02 | SITE STRATEGY

03 | OPINION RESPONSE

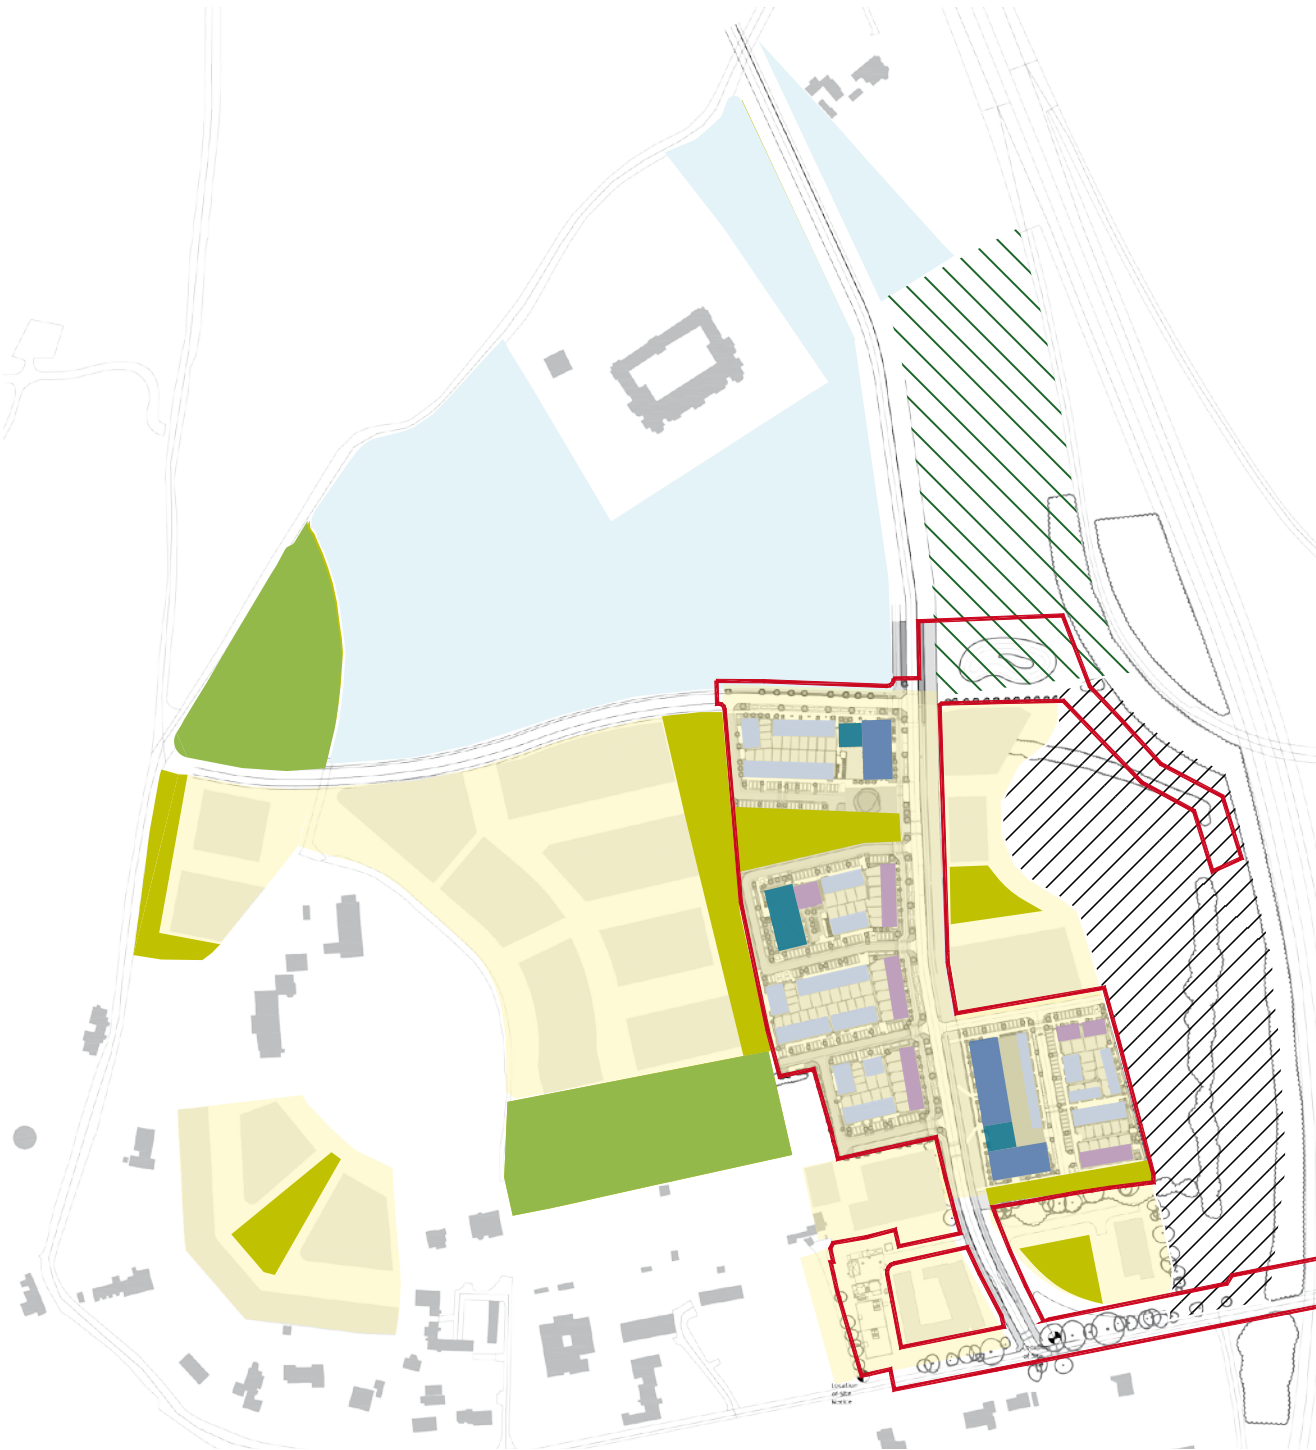
“The LAP identifies appropriate height range of 2-3 storeys for houses and 4-4+ setback on the subject site.

If heights above the range identified in the LAP are proposed, details of compliance with Policy Objective BHS2 and Table 5.1 of Appendix 5 of the County Development Plan 2022-2028 should be provided.”

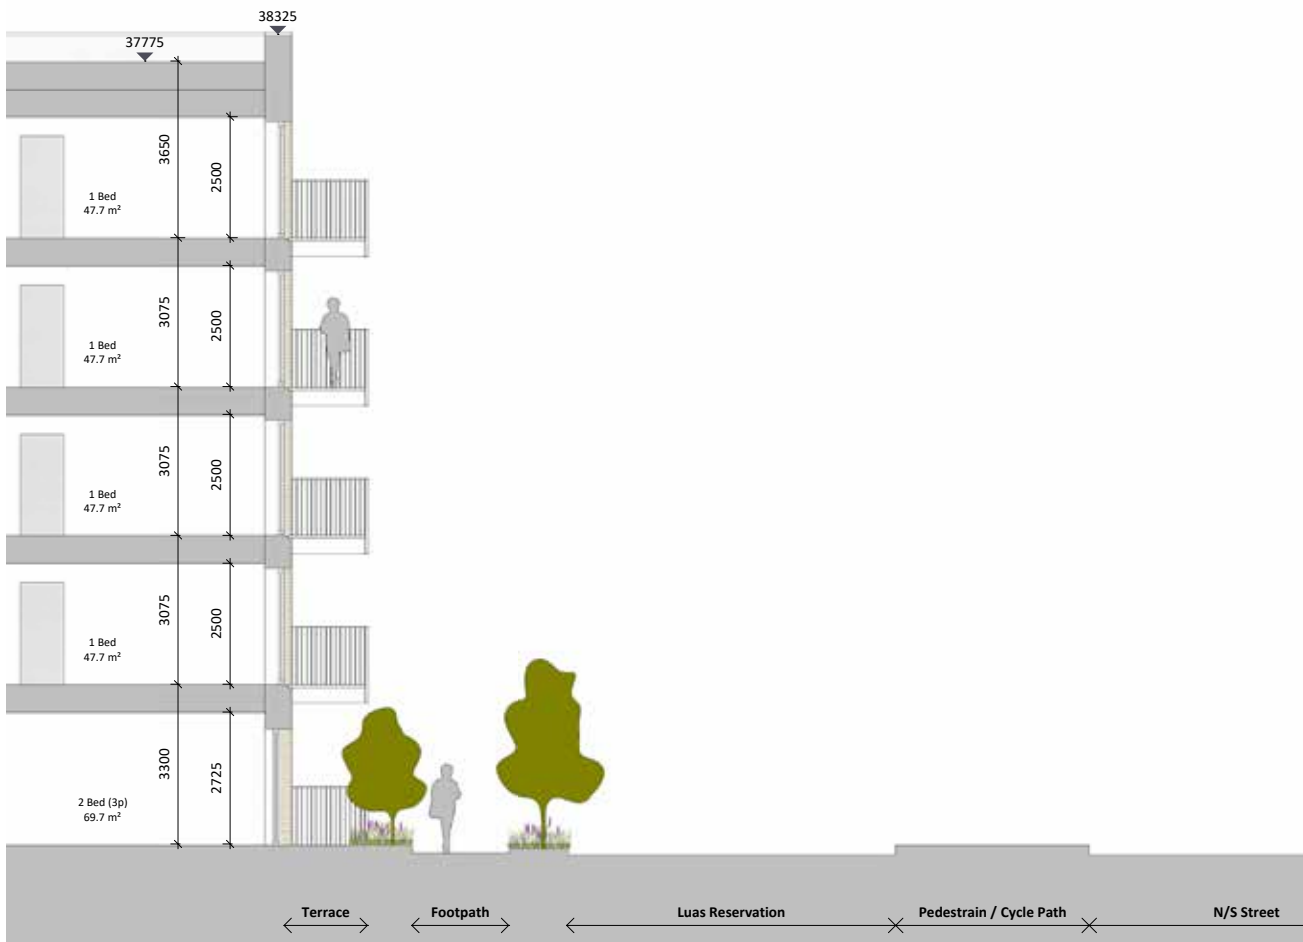
- Strong building frontages/ urban edge required along the primary north-south street, particularly the provision of articulation/design features at important corner sites such as north-east corner of Block 3.*
- Quality of balconies at Blocks 1 and 2 close to the Luas and potential impact on residential amenity in terms of noise.*
- Design at ground floor of apartment blocks to ensure activity on/interaction with street, particular west façade of Blocks 1/2. Particular consideration will be required for ground and first floor units in the proximity of the LUAS line.*
- Details of how proposed design achieves a strong sense of place with a village feel.*

The proposed scheme provides strong building frontages along the primary north-south street, with Blocks 1&2 and Block 3 bookending the street at its northern and southern ends respectively. The streetscape in between these bookends is characterised by tall, 3 storey gable fronted houses, which create a strong urban streetscape. A warm, buff coloured brick is the dominant material on the street, creating a unified streetscape. Block 3, at the northern end of the street, is distinguished by the use of a lighter brick, highlighting the importance of this building.

We note that the balconies of Blocks 1 & 2 will be a high quality, prefabricated system, in a RAL colour that matches the proposed windows in the scheme. On the western side of Blocks 1 & 2, there is a landscape area around the ground floor units of c. 2.5m depth, a 2m footpath and a 1m planted hedge. The distance from the outer (western) side of the proposed balconies to the edge of the Luas Reservation is c. 3.8m. Please refer to the Noise Assessment submitted as part of this planning application for further detail.

Construction Phasing Diagram

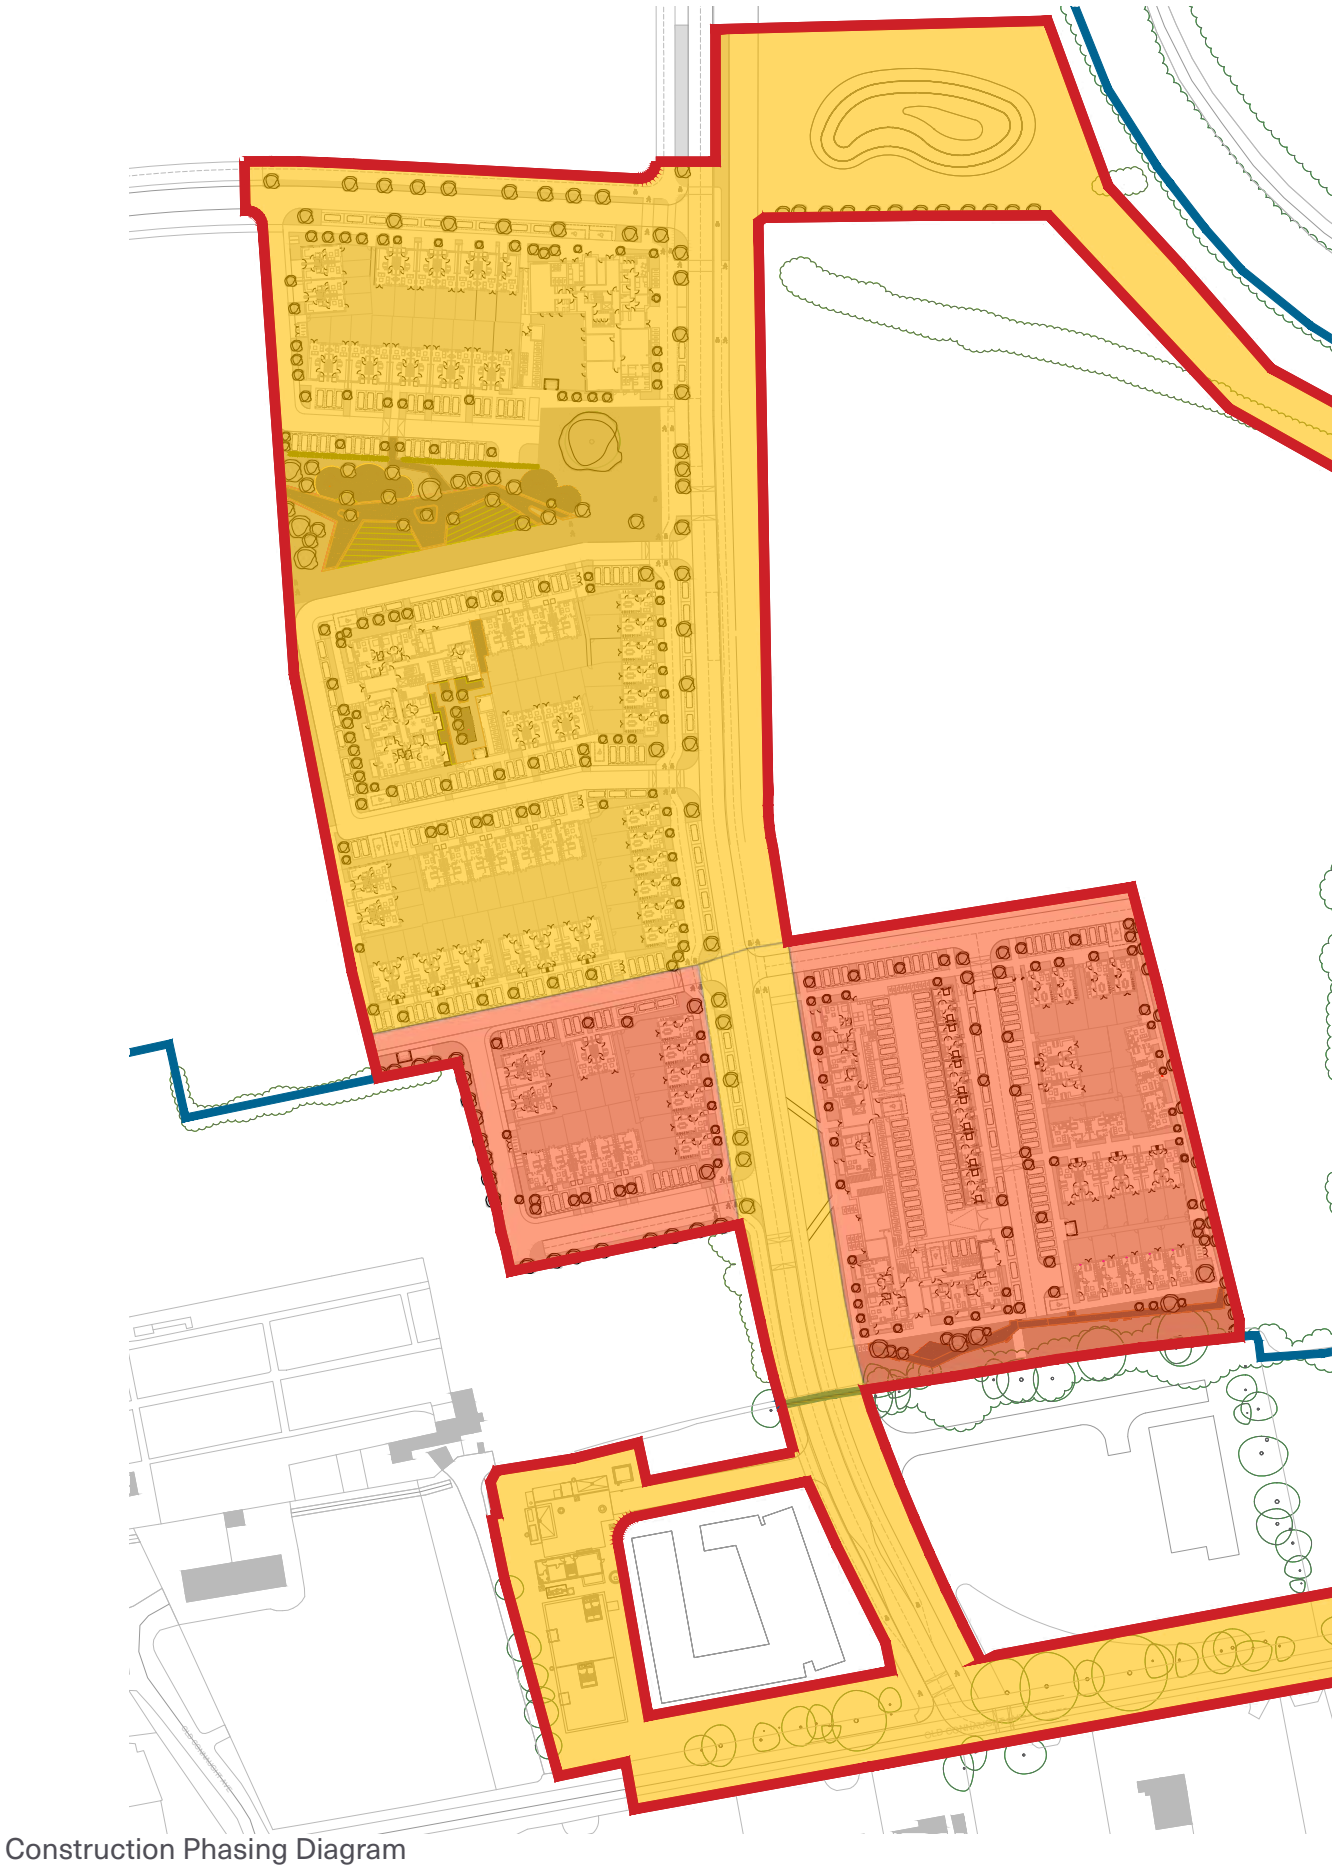
“The Planning Authority has concerns regarding the provision of creche in Phase 3. Preference would be for creche to be provided in Phase 2 to ensure services for future residents are provided in a timely manner.”

The proposed development will be delivered in two phases, with the creche scheduled for delivery in Phase 1. This phase is an appropriate stage at which to provide childcare facilities for existing and future residents. Delivering the creche at this point ensures that community infrastructure is introduced in line with the growth of the resident population and anticipated demand for childcare services.
